Z-82
(2015)

SITE PLAN FOR: VENTURE HOMES
167 CHURCH ROAD
2ND SECTION
COBB COUNTY, GA

ZONING COMMENTS:

Z-82 VENTURE HOMES, INC.

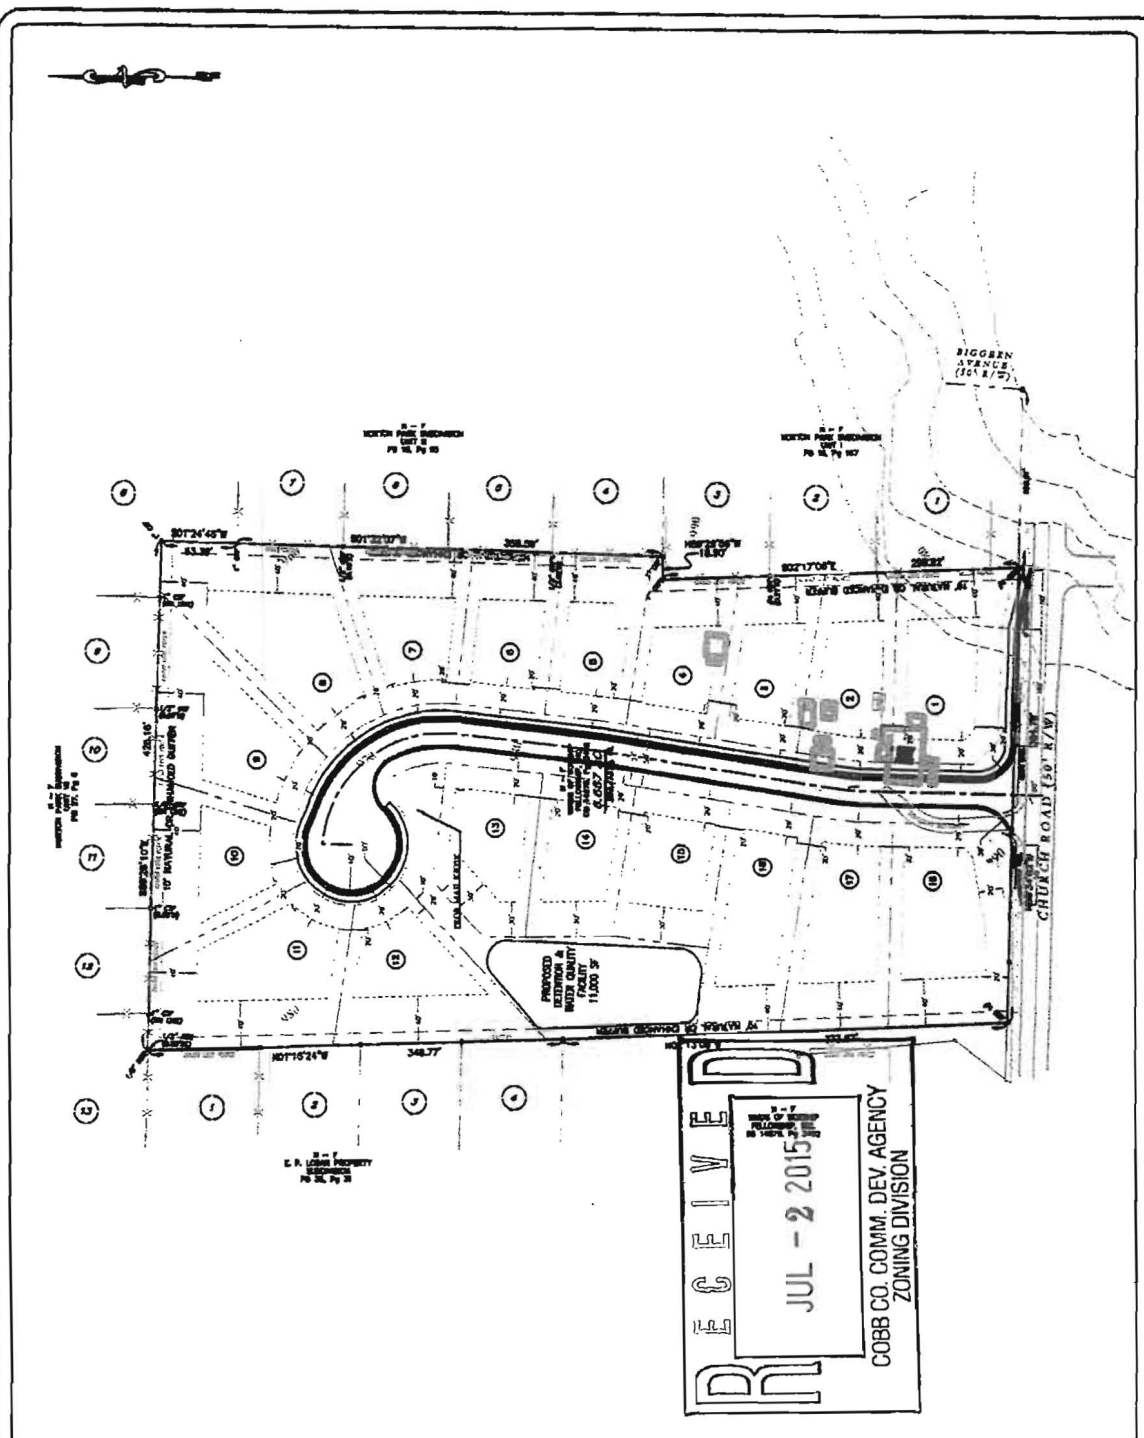
- No Stormwater controls shown _____
- Copy of survey is not current – Additional comments may be forthcoming when current site conditions are exposed.
- No site improvements showing on exhibit.

1. The discharge from the proposed stormwater management facility flows to the west through the adjacent church’s parking lot to an existing culvert under Norton Circle. This discharge must be conveyed directly to this existing culvert. A drainage easement from the church will be required. The peak allowable discharge from the site may be limited by the existing downstream capacity which must be evaluated at Plan Review.

- B. It is Staff's opinion that the applicant's rezoning proposal will not have an adverse affect on the usability of adjacent or nearby property. This is developed with subdivisions with similar uses and densities. The proposed site plan includes the required landscape buffer along the exterior boundaries of the property.
